ADDENDUM NO. 4

October 7, 2024

**South Westnedge School Remodel & Site Improvements
3333 South Westnedge Avenue
Kalamazoo, MI 49008**

This Addendum consists of Pages ADD 4-4 and attached TowerPinkster Addendum No. 4, dated October 4, 2024, consisting of 43 pages.

UPPER LEVEL PLUMBING PLAN - UNIT C
1/8" = 1'-0"

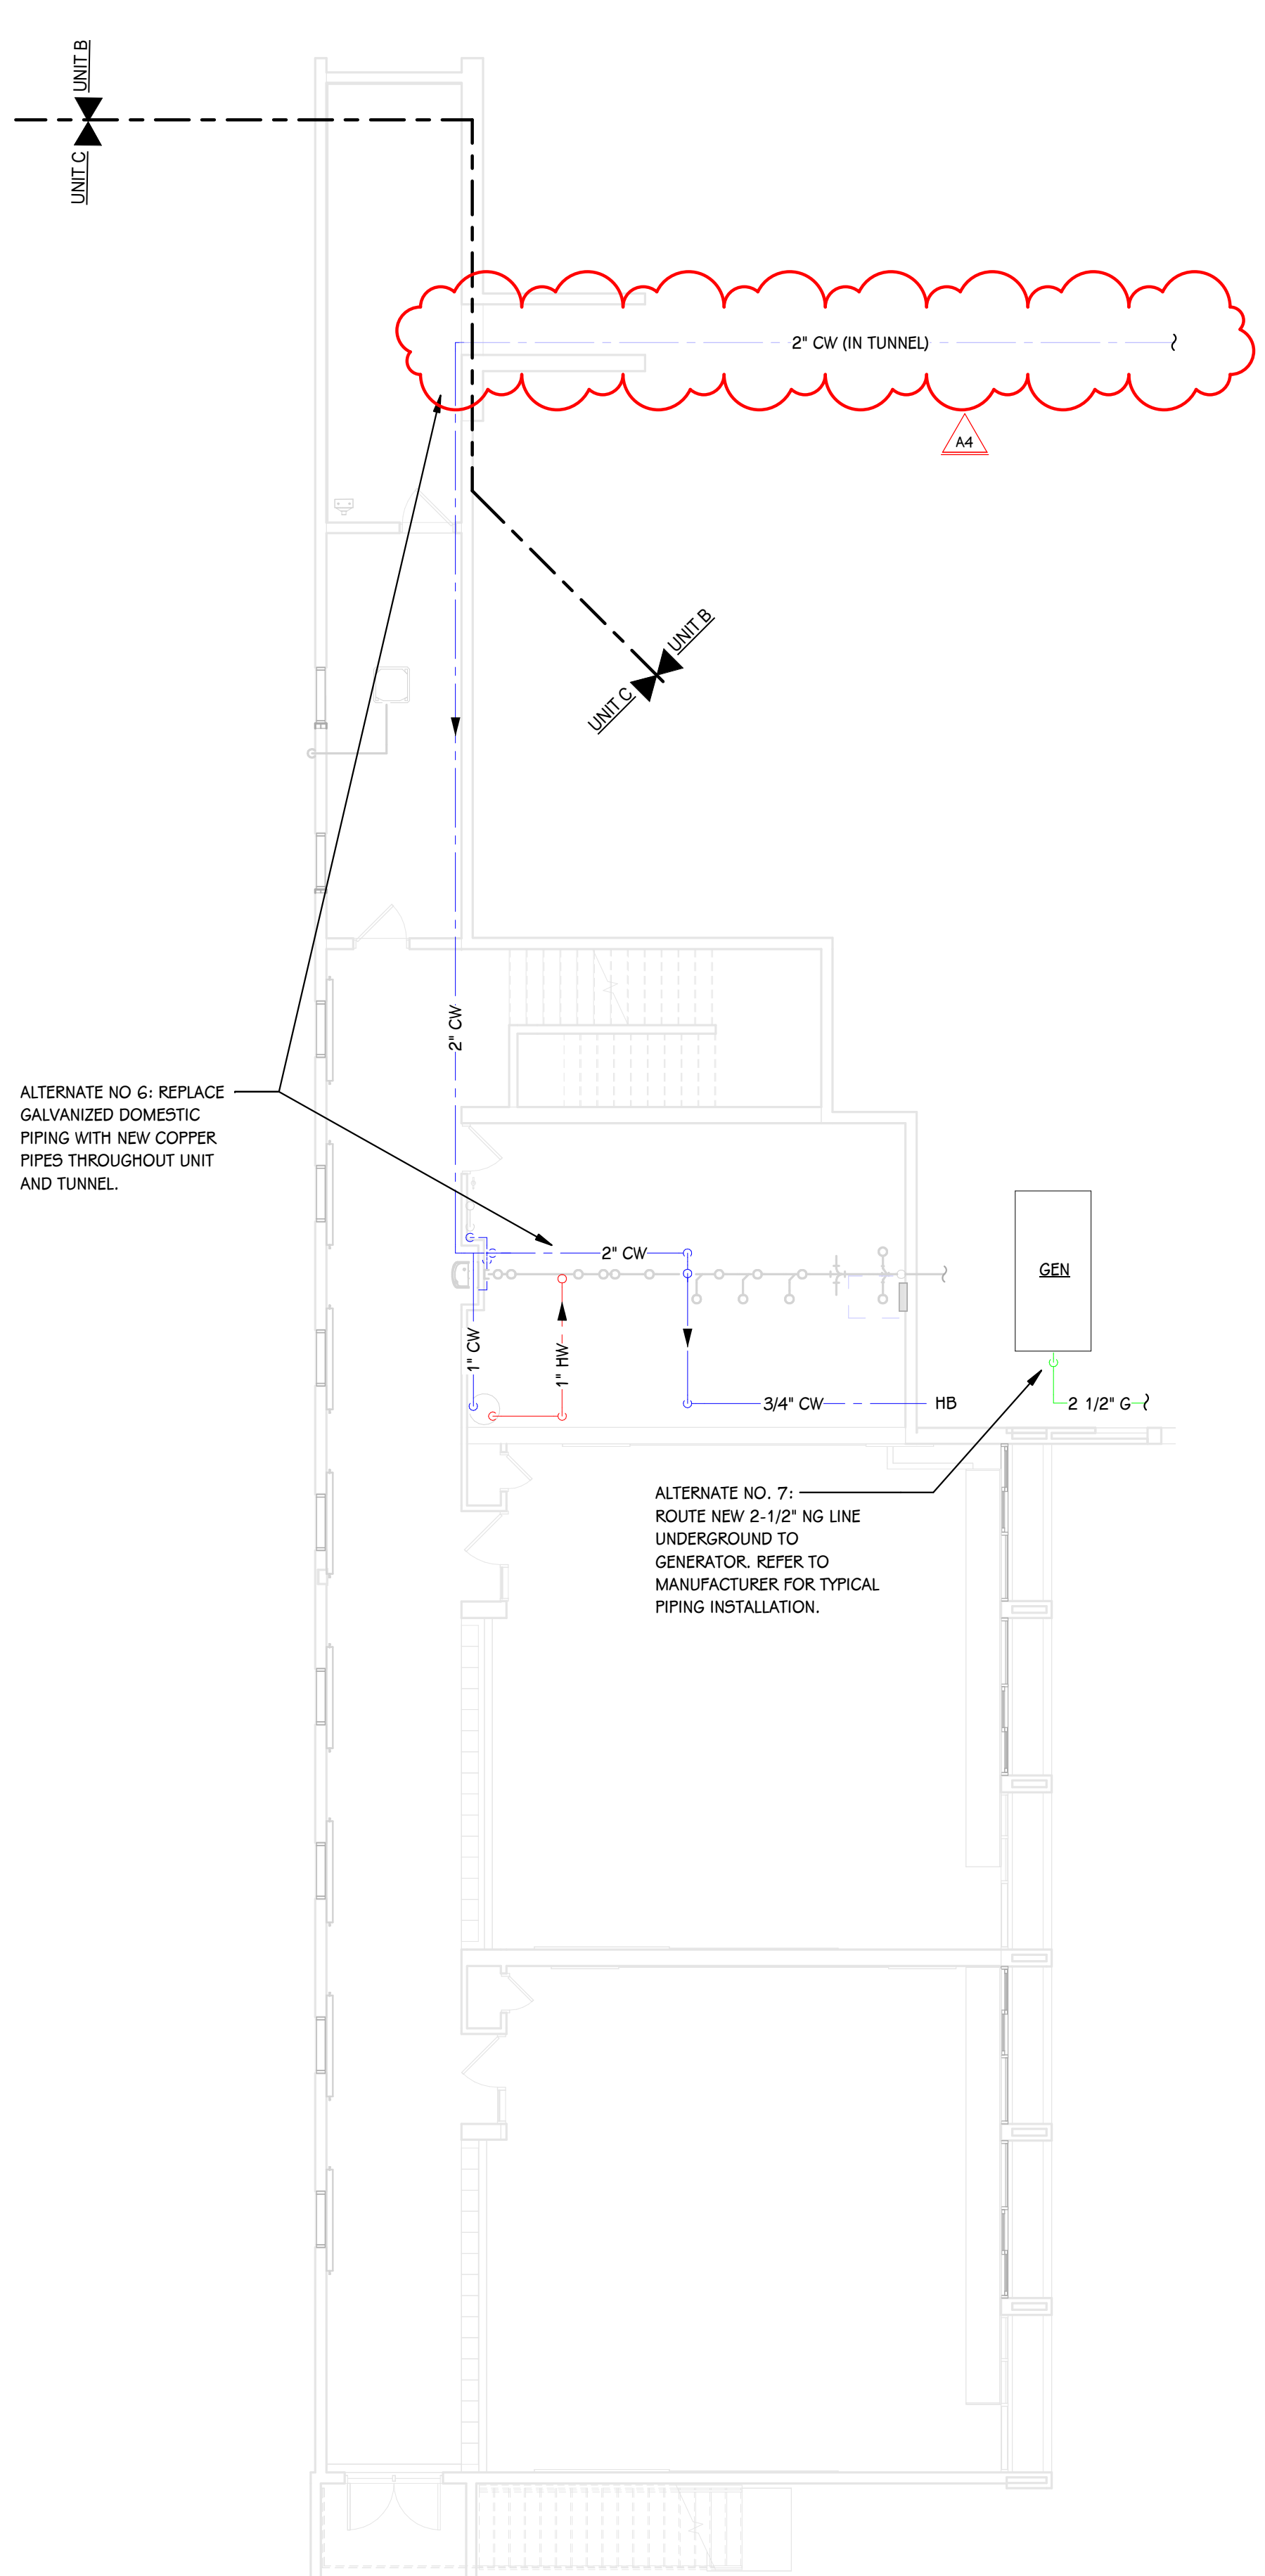
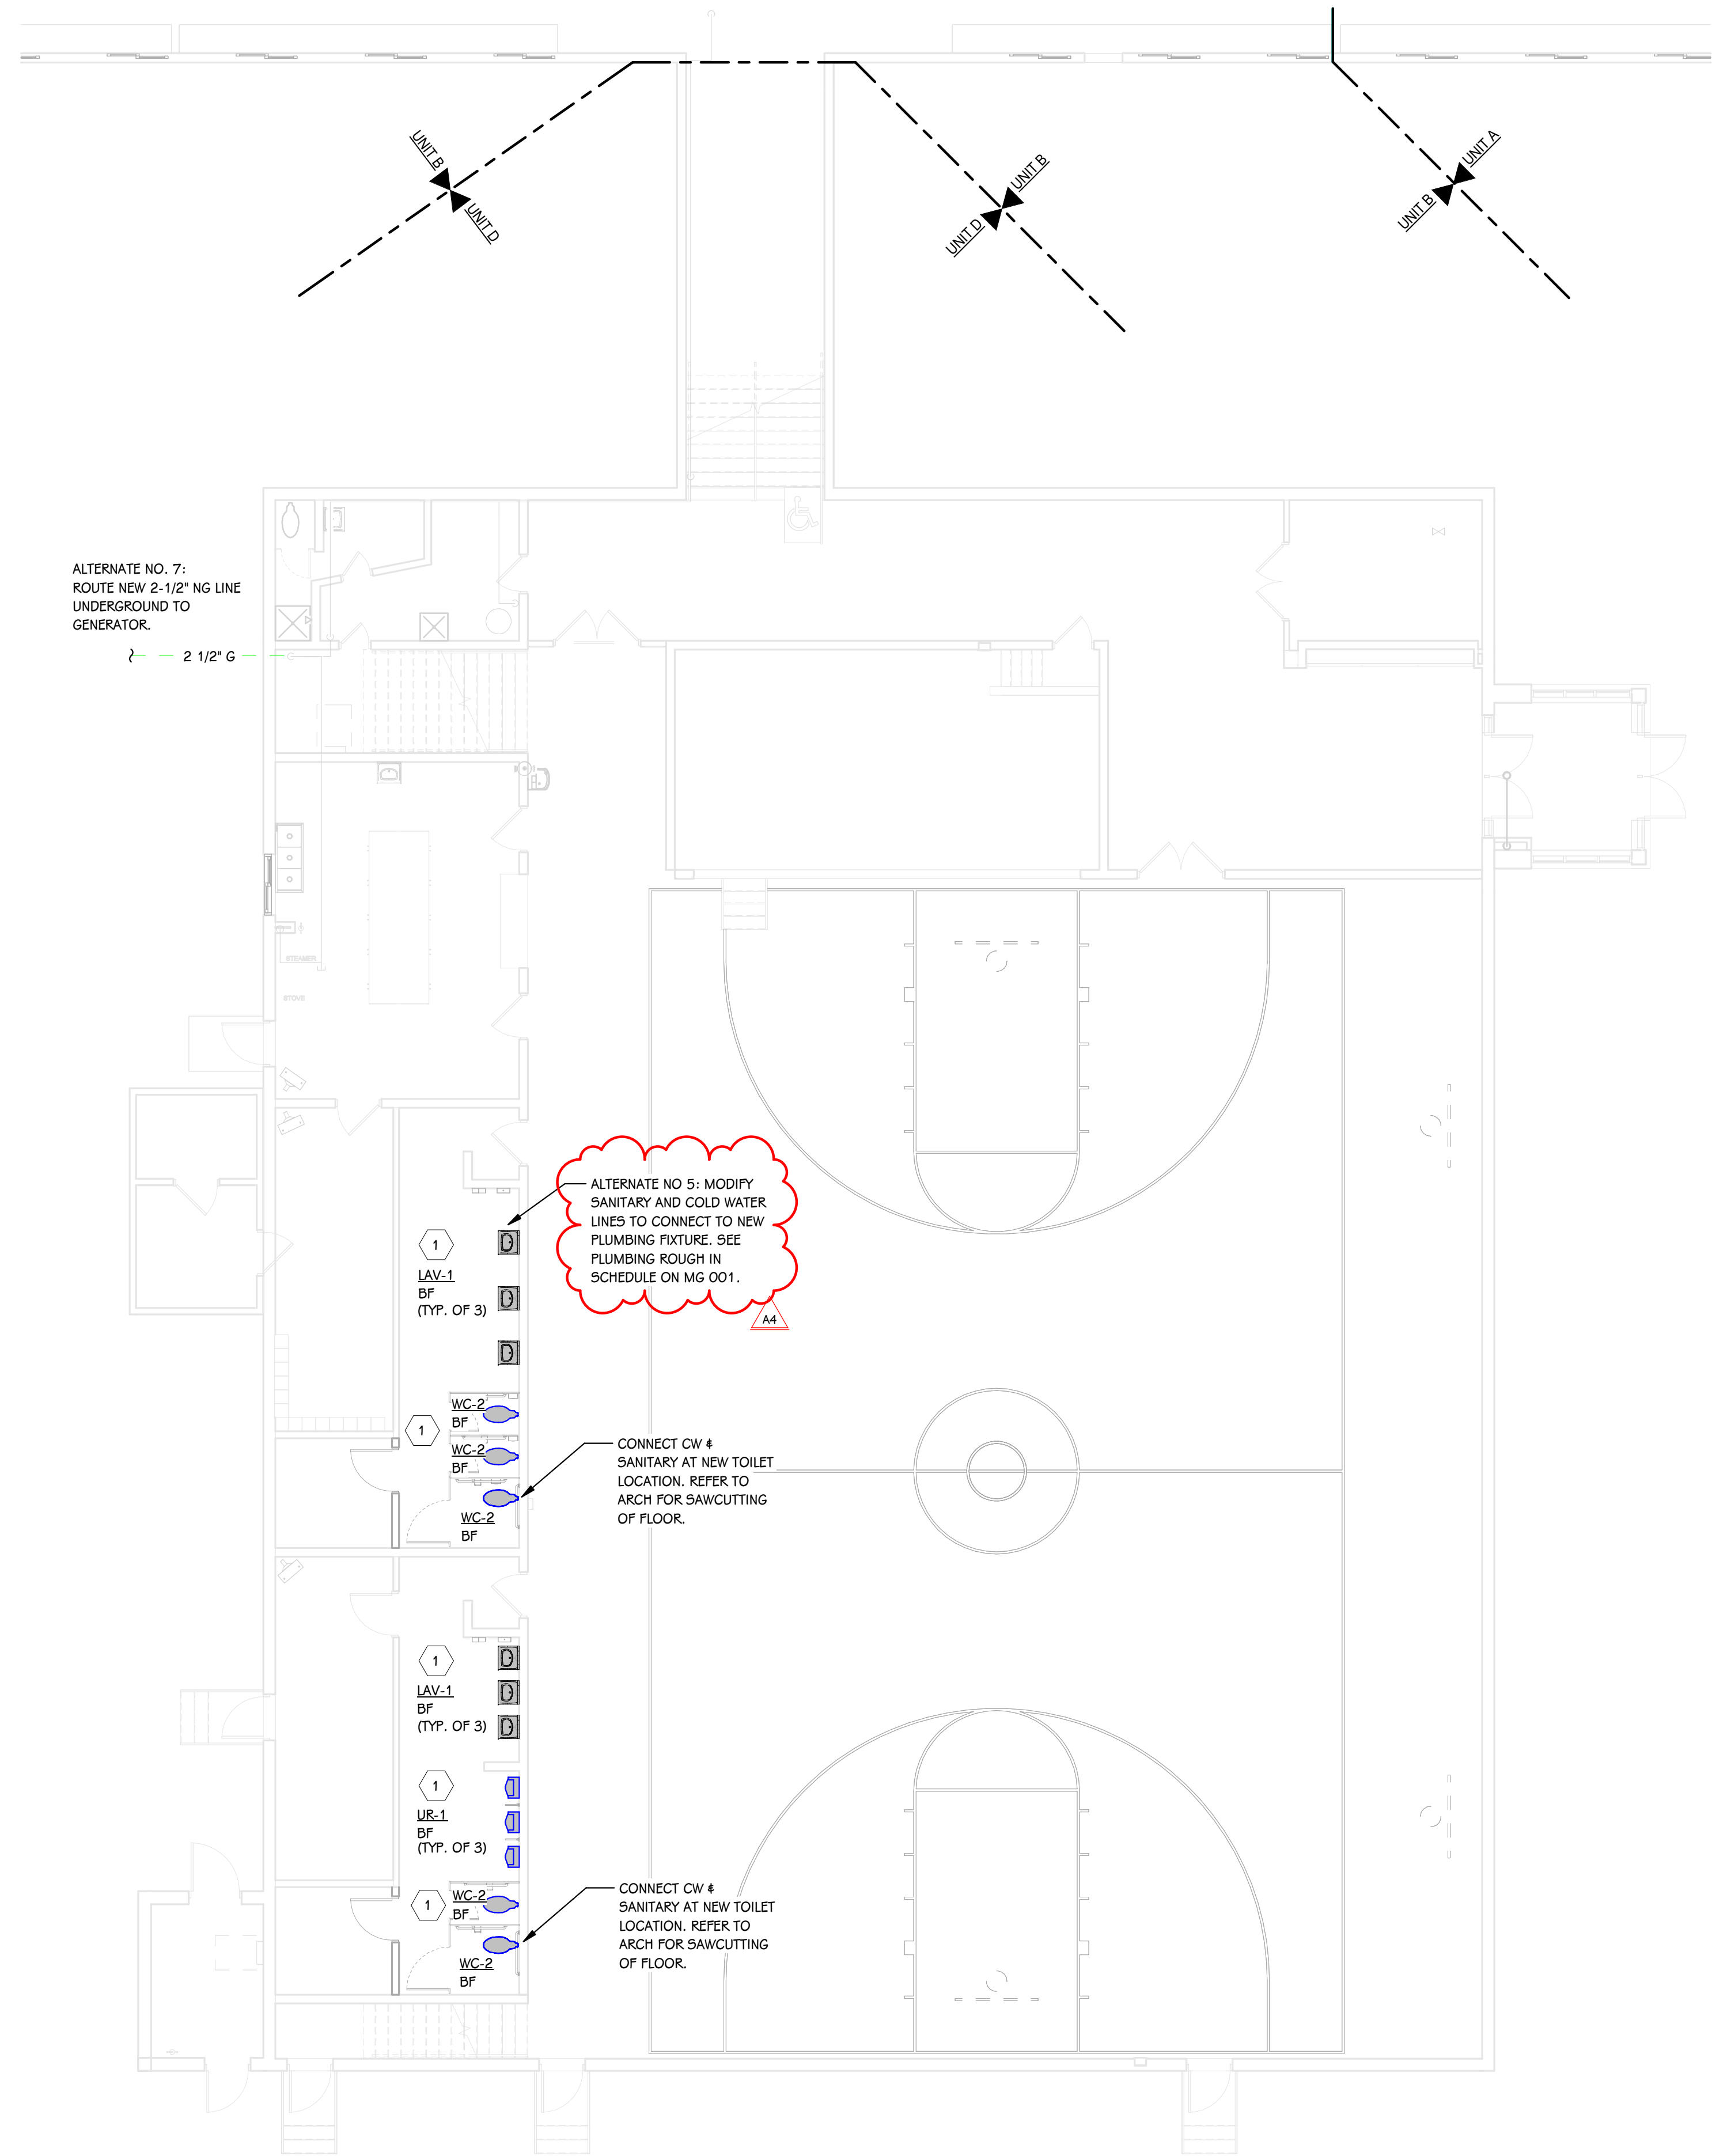
Refer to Sheet(s): P 801B, P801C, P 801D, PD 801A, PD 801B, PD 801C, PD 801D

Added demo sheets for the Alternates 5 & 6. Updated notes to provide clarity. Alternate 6 to replace all galvanized piping throughout units A, B, & C and within tunnels.
